গণপ্রজাতন্ত্রী বাংলাদেশ সরকার  
শ্রম ও কর্মসংস্থান মন্ত্রণালয়  
কলকারখানা ও প্রতিষ্ঠান পরিদর্শন অধিদপ্তর

ক্যাপ পর্যবেক্ষণের তথ্য

কারখানার নাম	আইসিয়ার ক্যাশনস লিমিটেড
ঠিকানা	55, SHOVPUR, RAJFULBARIA, SAVAR, DHAKA
কারখানার কোড	DHK028
কালার কোড	
মূল্যায়নের ধরণ: <a href="#">কঠামোগত মূল্যায়ন</a>	পর্যবেক্ষণের তারিখ: <a href="#">০৯-০৪-২০২৩</a>
১. পর্যবেক্ষণ

পরিদর্শন পর্যবেক্ষণ	Approval drawings and As-built drawings
ক্যাপ আইটেম ক্যাটাগরি

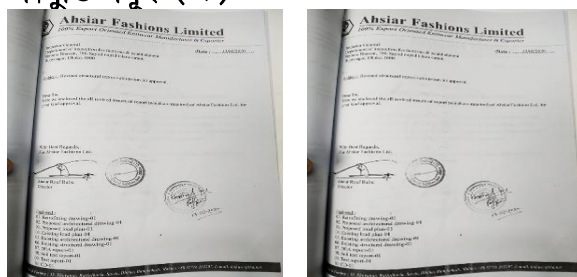
কার্যক্রম	As-built architectural and structural drawings of buildings to be prepared and submitted for approval by appropriate authority. As part of this process the building engineer will be required to make a number of checks on the inconsistencies between the structural design and the as-built construction.
সুপারিশের তথ্যসূত্র	
কারখানার কার্যক্রম	We have taken initiative and it will be implemented within timeline.
অগ্রাধিকার	৬ মাস
চূড়ান্ত সময়সীমা	০৮-০৫-২০১৮
সংশোধিত সময়সীমা	০১-০১-১৯৭০
অগ্রগতির অবস্থা	চলমান
মন্তব্য	<p>Previous timeline: 20/12/2016 Final Timeline: 08/05/2018 Factory has taken initiative and they have agreed to implement within timeline. 02/09/2020: DEA reviewed &amp; accepted on 146th Taskforce meeting. Approved drawings found in factory during visit. Retrofitting should be completed within 09/04/2020. Due to Covid-19 pandemic no retrofitting work started yet, said by factory Admin Manager. During visit we've found that there is total 3 buildings in the compound but just 2 buildings are included in design &amp; drawings. This building is adjacent to other 2 buildings &amp; this building should be included to design and drawings. All three buildings should included in the design &amp; remediated properly as per design. Now the factory management is instructed to submit all design &amp; drawings of this building along with the emergency steel stair within 15/10/2020. 28/03/2021: On 08/12/2020 on 152nd structural taskforce meeting the factory management were told to complete the retrofitting works of building 1 &amp; 2 within 31/03/2021. In the mean time the work on DEA of Building 3 should be completed. But no work regarding these issues are started yet. No retrofitting works are being started and no structural works of Building 3 are started yet. Now the factory management is instructed to start the retrofitting works of building 1 &amp; 2 immediately and submit all design &amp; drawings of the building 3 along with the emergency steel stair within 15/04/2021 by an enlisted firm of DIFE to DIFE RCC. 26.08.2021: The factory management is instructed to start the retrofitting works of building 1 &amp; 2 immediately and submit all design &amp; drawings of the building 3 along with the emergency steel stair within one month by an enlisted firm of DIFE to DIFE RCC. 23/08/2022: All Design drawings have received approval from DIFE. No retrofitting work was started. 09/04/2023: All Design drawings have received approval from DIFE. Retrofitting work has not started.</p>
